The proposal: MCU18/0190.04

The minor change application MCU18/0190.04 as submitted, “*seeks the **removal** of conditions 70 (a) – (c)*” and offers no enforceable alternative to the certainty and validity of reliance on Council’s DA approval conditions.

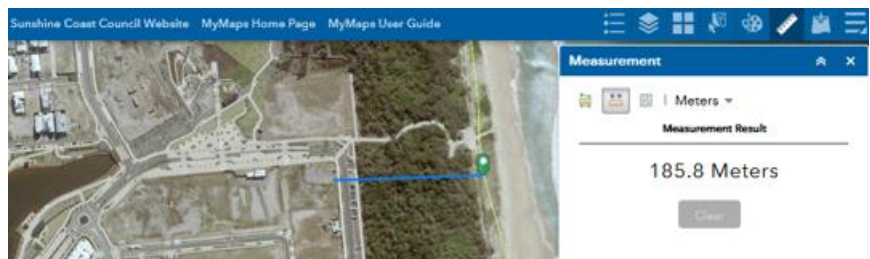
Suggested wording in the documentation referenced in this minor change application attempts to link comparative values for Turtle Lighting conditions applied to the Bokarina Seanna Apartments and the Beachfront Buddina Apartments.

Apart from the coincidences of the same construction company (*Tomkins*) and the same town planners (*Project Urban*), nothing in terms of (i) assessment processes and (ii) the development sites are in any way, comparable.

The instruments are incongruent, as are the sites, as shown in the table below:

Accordingly, any *loose* comparison of turtle lighting conditions (set by differing assessment approval instruments and site circumstances) should be disregarded.
